COA # 2011-COA-255 (FP)	INDIANAPOLIS HISTORIC PRESERVATION COMMISSION STAFF REPORT	Hearing Date SEPT. 7, 2011
646 Virginia Ave FLETCHER PLACE		Continued from: August 3, 2011
Applicant HAROLD MILLER mailing address: 646 Virginia Ave Indianapolis, IN 46203		Center Township Council District: 19 Dane Mahern
Owner: Same		
CASE		
IHPC COA: 2011-COA-255 (FP)	<ul style="list-style-type: none"> • Modify storefront openings as per plans • Modify window openings on rear of building (work already started). • Restore original front entry 	
STAFF RECOMMENDATION: Approval with stipulations		
STAFF COMMENTS

STAFF RECOMMENDED MOTION

2011-COA-255 (FP)

PROPOSED VIRGINIA AVENUE ELEVATION

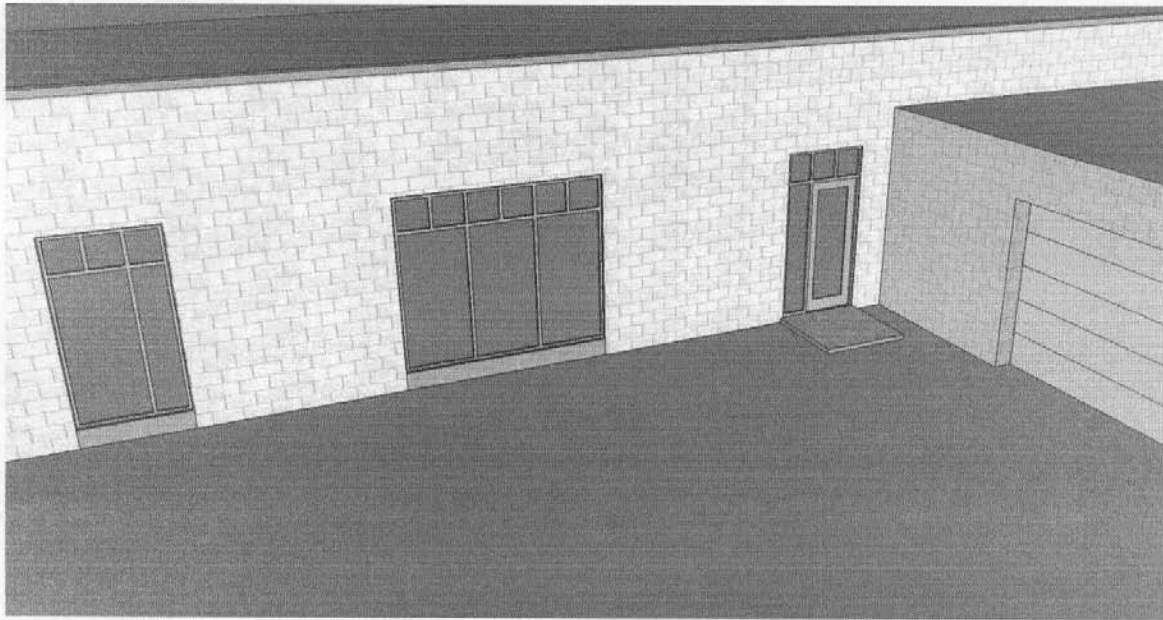
1. **Round Window**. This has been the source of discussion between staff and the architect. While staff believes the contemporary design of this entry is generally compatible with the building, we find the round window element to be a visual distraction, as it becomes the first element one sees and is entirely at odds with all other elements of the building. Staff believes a square window would achieve the same practical need and also echo the squared off features found in the transom windows and the brick panel in the raised parapet.

It is staff’s understanding that the owner still prefers the round window, but may be willing to change to a square window if the IHPC requires it. Staff recommends that it be removed.

2. Unfinished Redwood. Staff has expressed a preference for painting the redwood, but the owner wishes to keep the redwood unpainted as proposed. This issue is not as important to staff as the round window, but we believe the IHPC should take it into consideration.

BIRDSEYE VIEW OF PROPOSED STOREFRONT AND DOOR INFILL

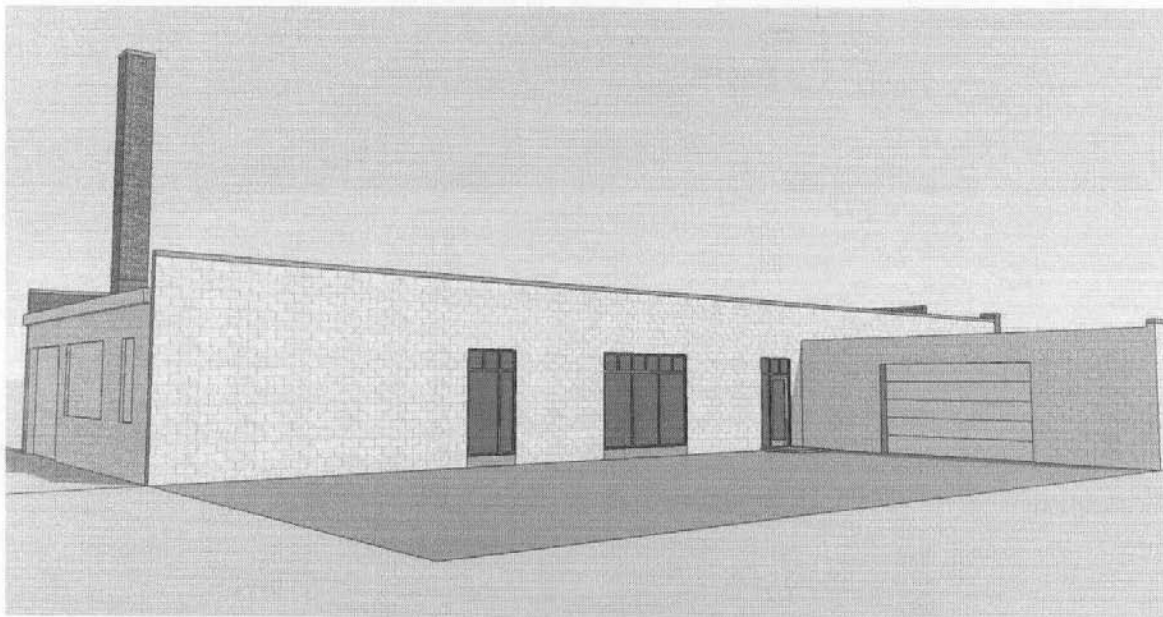
Staff’s believes the garage door is probably not original. The proposal is to remove it and replace it with a new recessed entry with a new door on one side wall, an unpainted redwood wall with round window at the back and a panel to display an oversized photograph on the other side wall. The new entry is for ADA compliance. The plans also show a wooden canopy projection.

While this entry is a completely contemporary expression, staff believes it is appropriate (with some exceptions explained below). The historic opening is not altered and the recessed nature of the entry reflects the fact that this large opening is historically a void in the façade. Furthermore, the contemporary elements visually appear to be on the interior to the building, and separated from the actual façade of the building --- almost as if one is looking into the garage space.

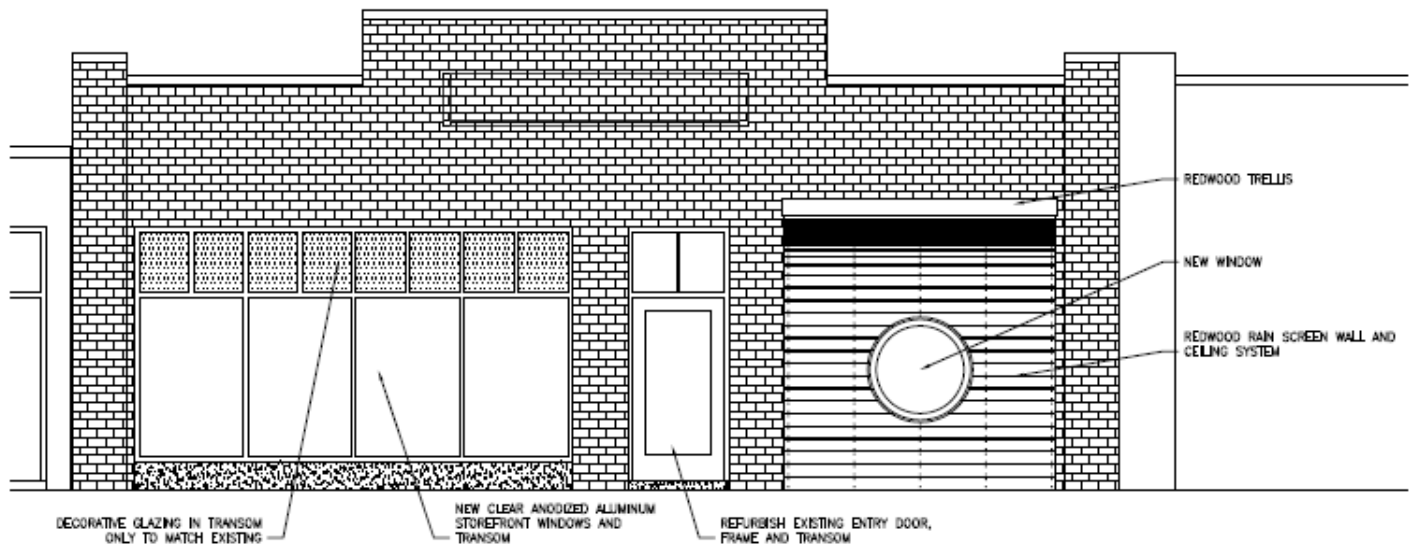
Near the rear of the building, there are three steel factory sash windows. The owner’s contractor started to enlarge one of the openings when a building inspector issued a Stop Work Order. That opening remains altered with plywood over the enlarged portion. The original window is still in the opening. However, the intent was to enlarge all three openings and install new windows and doors as per the drawings. Staff believes the steel windows are interesting, but because they are not visible from most angles, they don’t contribute significantly to the architecture of the building despite their age and character. Staff believes that the proposed alteration is appropriate and a reasonable way to convert this building for a new use, even though the work was started without approval.

This image shows the rear of the building and the three openings that are being requested to be enlarged and replaced with new windows.
